This record drawing is a compilation of the sealed engineering drawing for this project, modified by addenda, change orders and information furnished by the contractor. The information shown on the record drawings that was provided by the contractor or others not associated with the design engineer cannot be verified for accuracy or completeness. This original sealed drawings are on file at the offices of Birkhoff, Hendricks & Conway, L.L.P.

<b>CITY OF ROCKWALL, TEXAS</b>			
FANNIN STREET IMPROVEMENTS			
COORDINATE/DIMENSION - PLAN			
STA. 15+00 TO STA. 20+00			
BIRKHOFF, HENDRICKS & CONWAY, L.L.P.			
CONSULTING ENGINEERS Dallas, Texas			
PROJECT ENGINEER: M.H.	PROJECT: 2005111	SHEET NO. 7	
PROJECT TECHNICIAN: J.M.	DATE: April, 2009

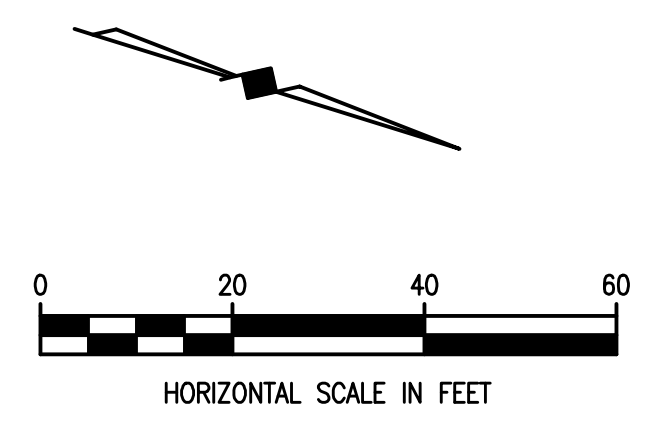
-  PROPOSED CONCRETE DRIVE
-  PROPOSED BRICK PAVERS
-  PROPOSED CONCRETE CURB AND GUTTER OR PROPOSED CONCRETE PARKING NICHE W/ VALLEY GUTTER & MONOLITHIC CONCRETE CURB
-  PROPOSED CONCRETE SIDEWALK
-  PROPOSED CONCRETE DRIVEWAY
-  FIELD CHANGE NO. 8 SIDEWALK REVISIONS (-5 S.Y. NET)

FIELD CHANGE NO. 8 (8/5/2008)  
 FIELD CHANGE NO. 3 (4/15/2008)
